CALIFORNIA ENERGY COMMISSION

December 7, 2009

**RE: PALEN SOLAR POWER PLANT (09-AFC-7), DATA REQUESTS
SET 1 (#1-280)**

DATA REQUEST - FIGURE 1
 Palen Solar Power Plant - North of Desert Center Alternative

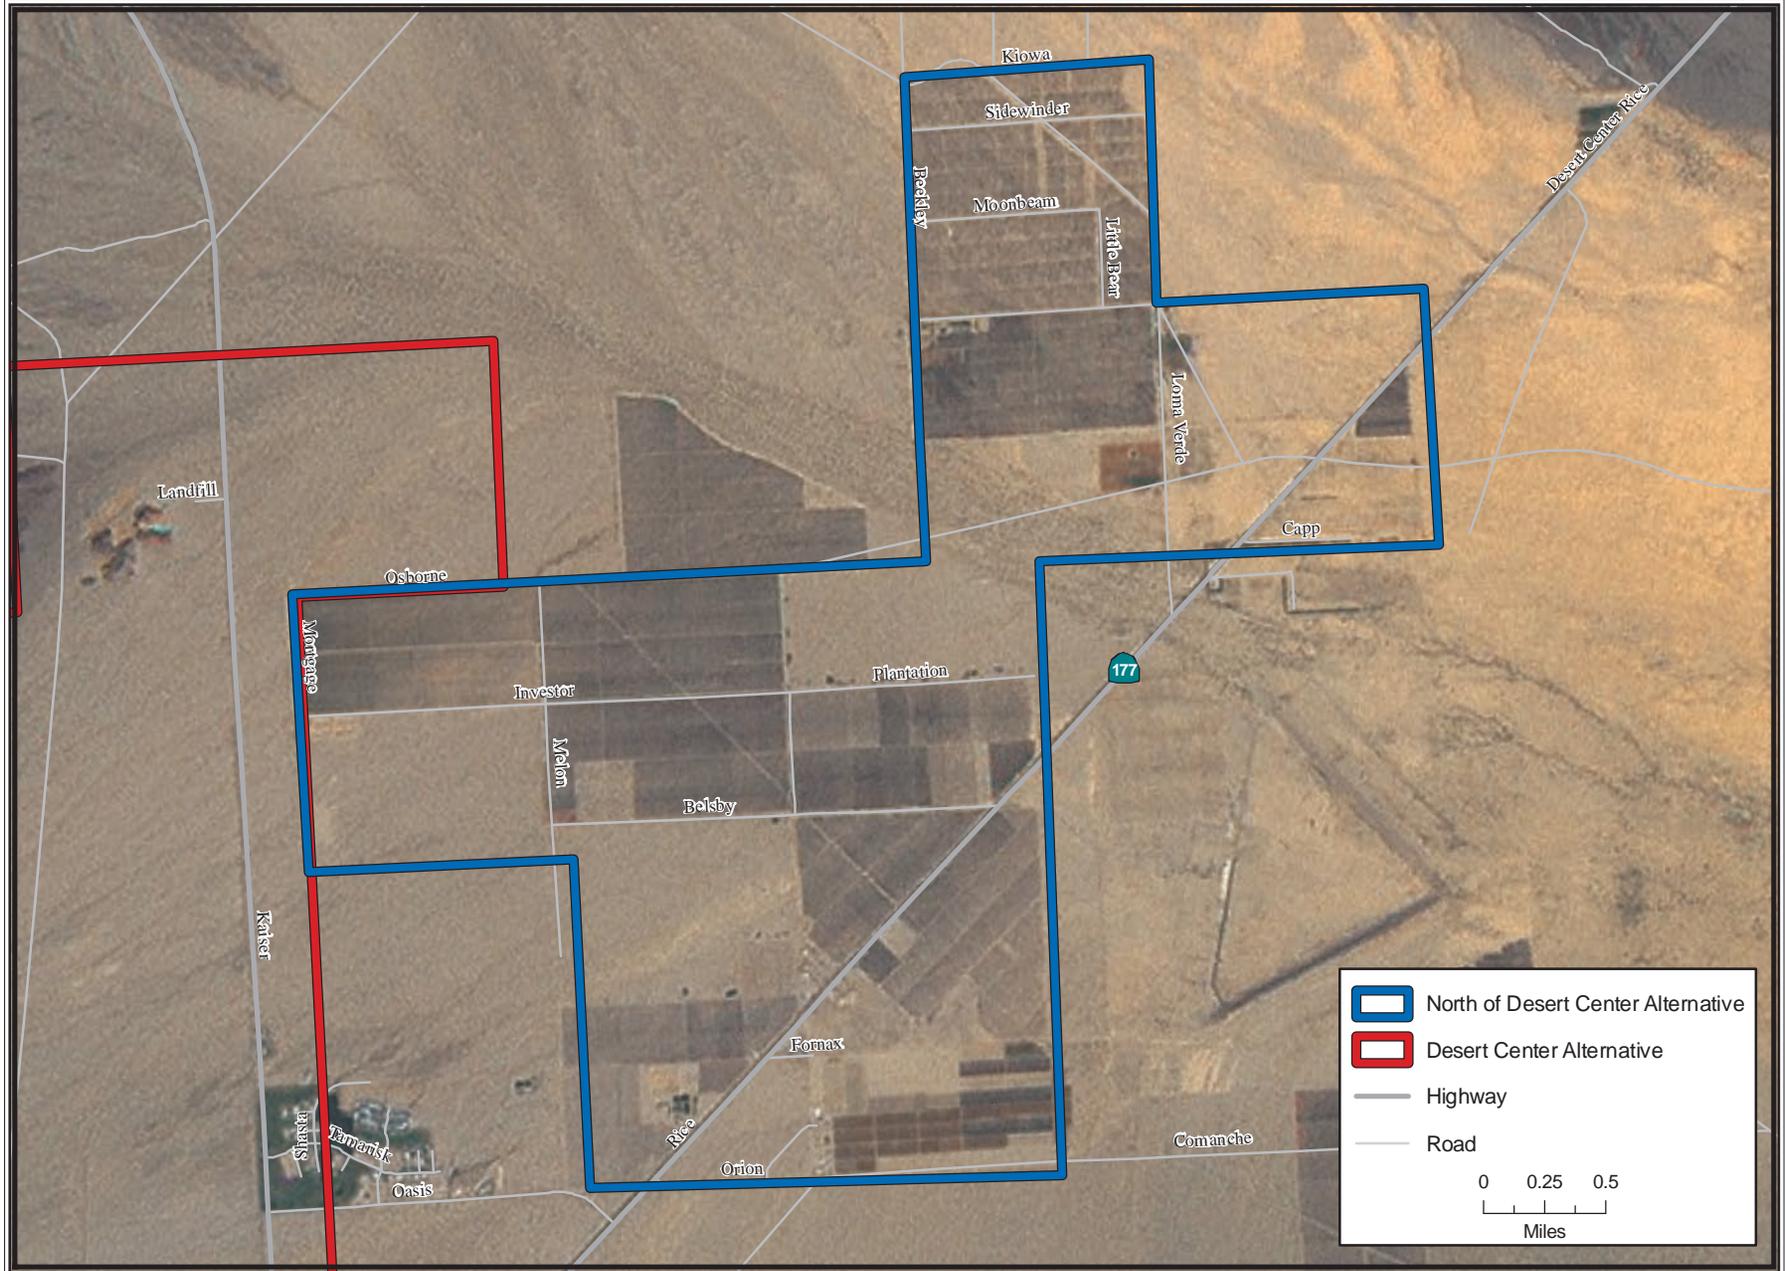
In order to define alternative sites that would be potentially viable, Staff has reviewed scoping comments (for the PEIS for solar development on BLM-administered land) and met with Energy Commission and BLM staff and identified other potentially viable sites. We have identified a potential additional site called the North of Desert Center alternative. A GIS file of the North of Desert Center alternative will be provided along with this data request. A map in PDF format is attached (see Data Request Figure 1).

40. One of the site selection criteria for the proposed Palen SPP site was environmental sensitivity. Please provide the results of a CNDDDB search for the North of Desert Center alternative site.

41. Please provide an Information Center search (Class I) for recorded sites identified within the North of Desert Center alternative site.

Alternatives Data Request Figure 2. Reconfigured Alternative.

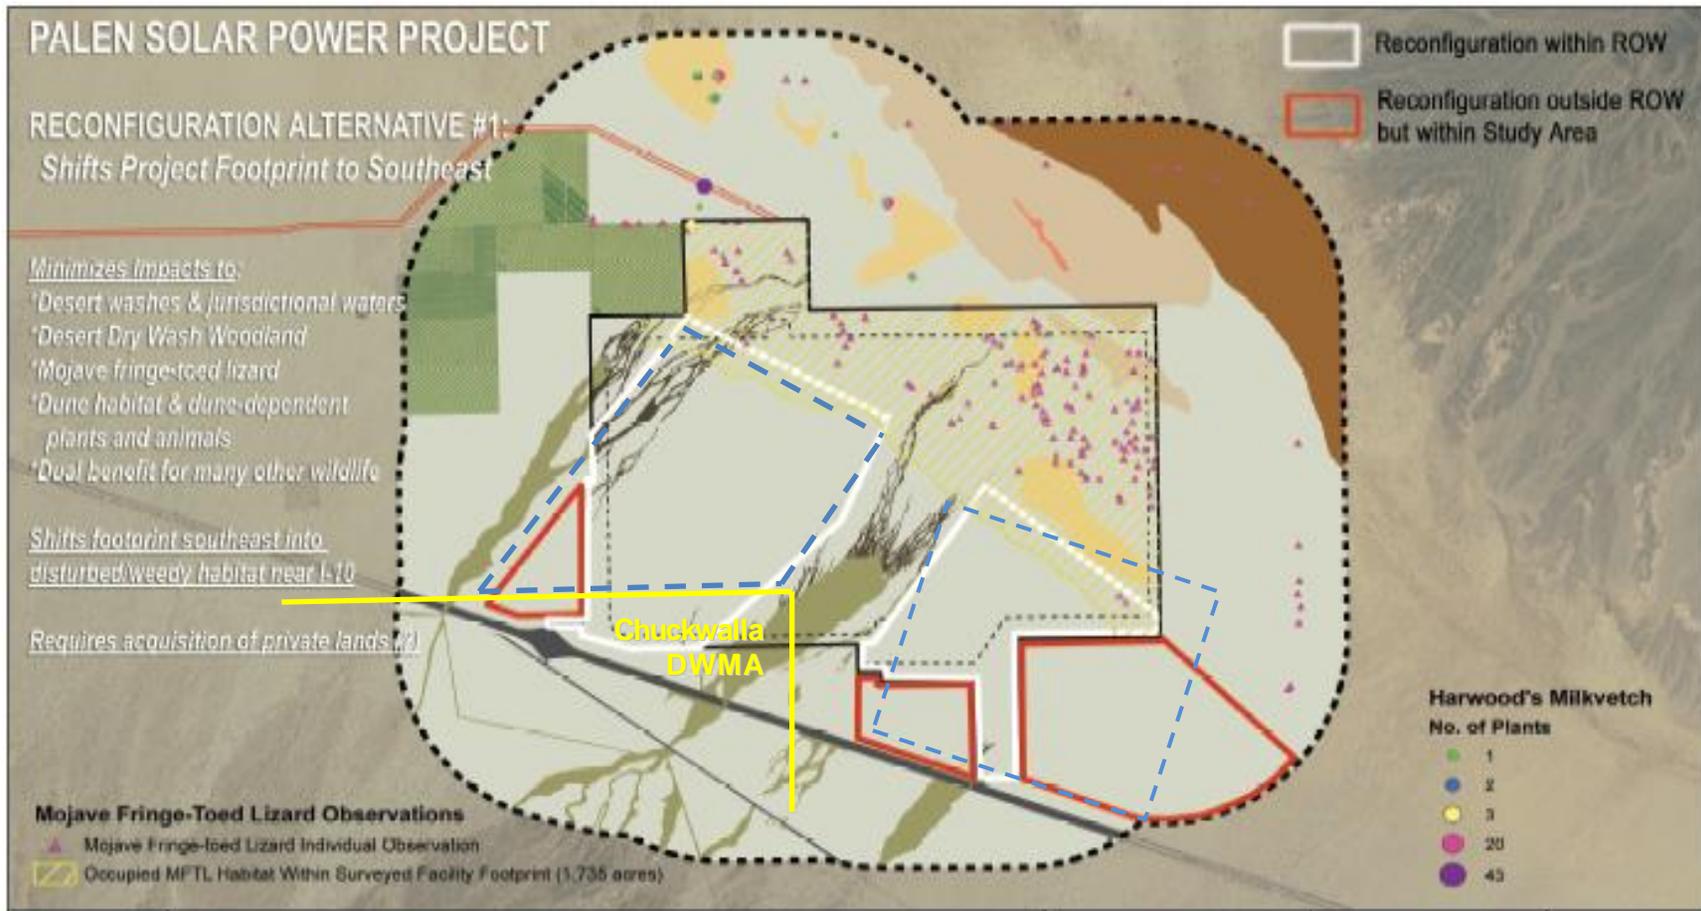
47. Please see **Alternatives Data Request-Figure 2**, which illustrates areas within the project boundaries that are occupied by the most sensitive biological resources -- desert washes (shown in green) and Mojave Fringe Toed Lizard habitat (shown in yellow crosshatch). The areas outlined in blue dashes, and red or white lines identify potential revised configurations that would reduce these effects. In addition, the yellow line illustrates the approximate boundary of the Chuckwalla DWMA. In order for the Energy Commission and BLM to evaluate a potential alternative that avoids effects on these sensitive areas without reducing generation output, surveys must be completed within the portions of these areas that are outside of the current project footprint. Please complete biological and cultural resources surveys (as defined in Title 20, Section 1704, and Division 2, Chapter 5, Appendix B of the CCR for the 12 month process) for the areas outlined in red and not included in the DWMA. Alternatively, complete biological and cultural resources surveys for other areas within the project ROW application boundaries (but outside of the current project footprint) that minimize effects on biological resources to the same degree as the areas identified on Figure 2.

Alternatives Data Request Figure 3. Reduced Acreage Alternative

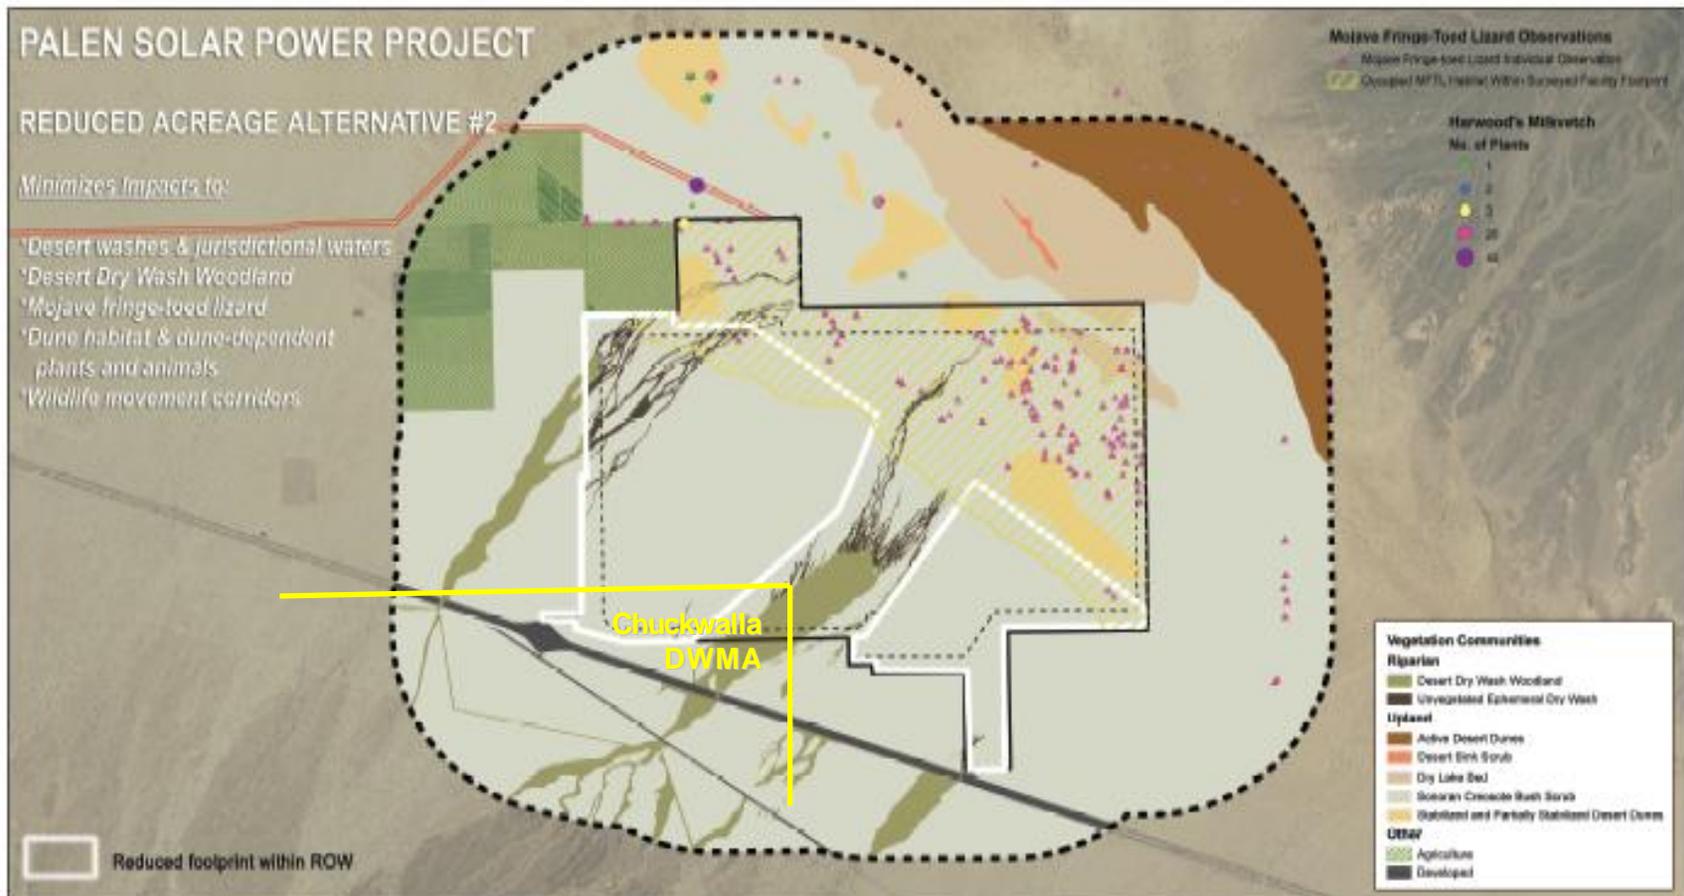
48. Please provide detailed information regarding the economic and engineering feasibility of a reduced acreage alternative that would avoid the most sensitive biological resources. See Data Request - Figure 3 as example of a reduced acreage alternative based on avoiding desert washes (shown in green), Mojave Fringe Toed Lizard habitat (shown in yellow crosshatch), and the Chuckwalla DWMA (yellow line). The entire reduced acreage alternative would be located within the project footprint.
